## **ADA ACTION PLAN**

**SEDGWICK COUNTY COMCARE – CITY CENTER**  
**154 N. TOPEKA, WICHITA, KS**  
**MAY 29, 2007**  
**< Updated August 4, 2008 >**

**Signs - Exterior**

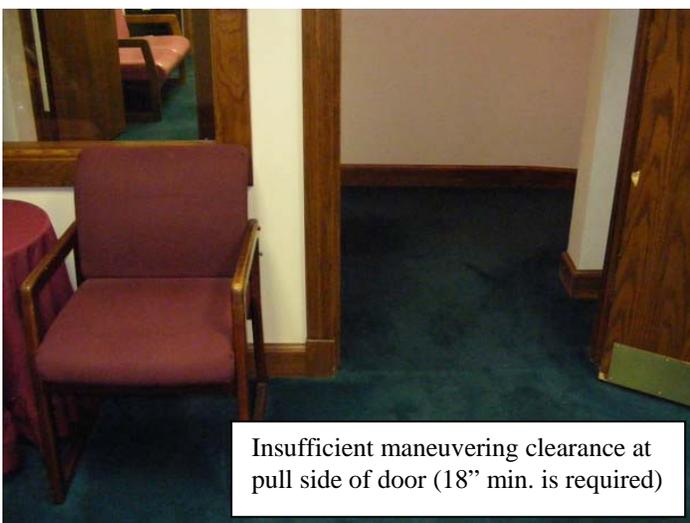
<p>The curb ramps, located on the path of travel (public sidewalk) to this facility, at the corner of 1st and Topeka have steep side flares, steep running slope (with slopes of 8.5 to 9%), and do not provide appropriate detectable warning surfaces. <b>Modify the existing curb cuts or work with City of Wichita to comply with the right-of-way law regarding curb ramps, to ensure compliance with ADAAG specifications pertaining to detectable warning surfaces and slope.</b></p>	<p>H</p>	<p><a href="#">Ramp</a></p>	<p><a href="#">Curb ramps</a></p>
<p>According to ADAAG, accessible entrances/exits must be provided, at a minimum, in the same number that local fire code requires entrances to exist. In other words, if local fire code requires two entrances at a facility, then both entrances are required to be accessible. In addition, accessible entrances are required to be part of an accessible route, which leads to transportation stops, accessible parking, and public streets or sidewalks. The symbol of accessibility does not exist at the main public entrance and directional signage does not exist at inaccessible entrances. Additionally, one inaccessible entrance is marked with the symbol of accessibility. <b>Provide the symbol of accessibility on accessible entrances and provide directional signage at inaccessible entrances. Ensure that sufficient accessible exits/entrances are provided to comply with fire code.</b></p>	<p>VH – Signage  M – Making additional exits accessible, if required by fire code</p>	<p><a href="#">Signs</a></p>	<p><a href="#">Signs - Exterior</a></p>

Signs

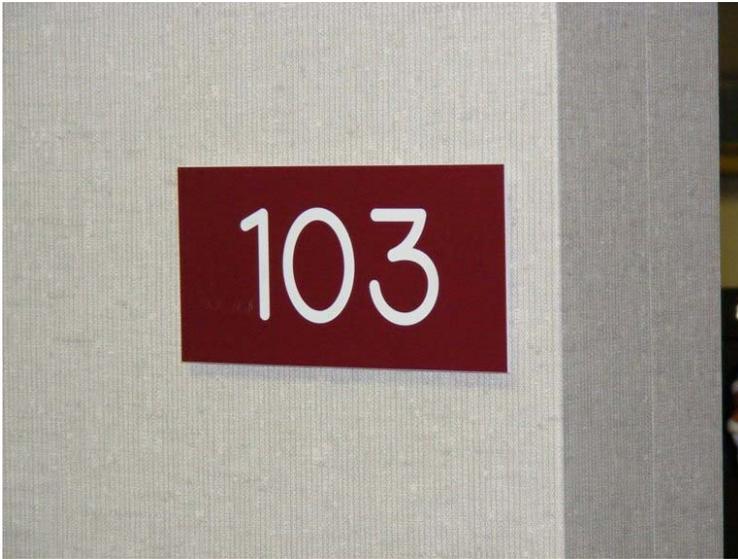
<p>Interior rooms and spaces, which are identified by number, do not provide Braille signage; and exit signs are not provided in Braille. <b>Provide compliant Braille signage at all interior doors as required by ADAAG. Follow the New ADAAG specifications for mounting of signage.</b></p>	<p>H</p>	<p><a href="#">Accessible Signage</a></p>	<p><a href="#">Signs</a></p>
<p>The reception counter is located too high. ADAAG requires a minimum 36-inch long portion of sales or service counters to be a maximum height of 36-inches. <b>Lower a minimum 36-inch long portion of the existing counter to a maximum height of 36-inches or ensure that a desk in close proximity to the counter is available and can be utilized when necessary.</b></p>	<p>L</p>		<p><a href="#">Front Counter</a></p>

**Womens Restroom**

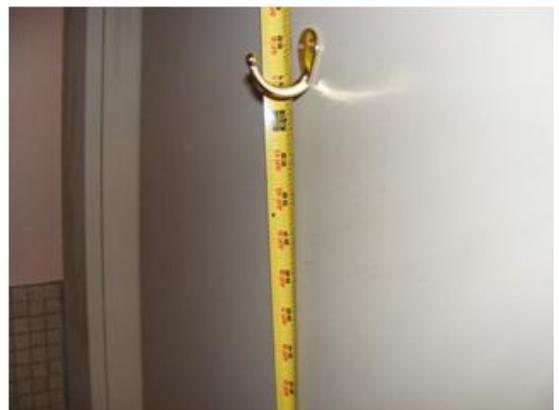
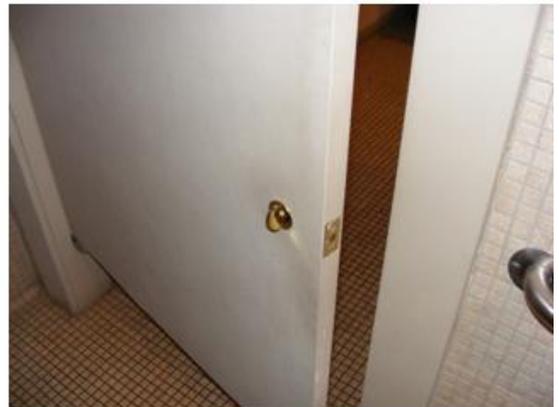
<p>The public women’s restroom is inaccessible due to numerous inconsistencies. Including, but are not limited to: narrow toilet stall, insufficient knee space at lavatory, lack of appropriate maneuvering space at the latch pull sides of entrance doors, dispenser locations, coat hooks located too high, etc. <b>No fully accessible restroom exists within this facility. An accessible unisex restroom on the first floor in close proximity to the existing restrooms may be the most cost effective alternative.</b></p>	H	<a href="#">603 Toilet</a> <a href="#">604 Water Closets</a> <a href="#">606 Lavatories</a>	<a href="#">Women’s Restrooms</a>
<p>The public men’s restroom is inaccessible due to numerous inconsistencies. Including, but are not limited to: narrow toilet stall, insufficient knee space at lavatory, lack of appropriate maneuvering space at the latch pull sides of entrance doors, dispenser locations, coat hooks located too high, etc. <b>No fully accessible restroom exists within this facility. An accessible unisex restroom on the first floor in close proximity to the existing restrooms may be the most cost effective alternative.</b></p>	H	<a href="#">603 Toilet</a> <a href="#">604 Water Closets</a> <a href="#">606 Lavatories</a>	<a href="#">Men’s Restrooms</a>
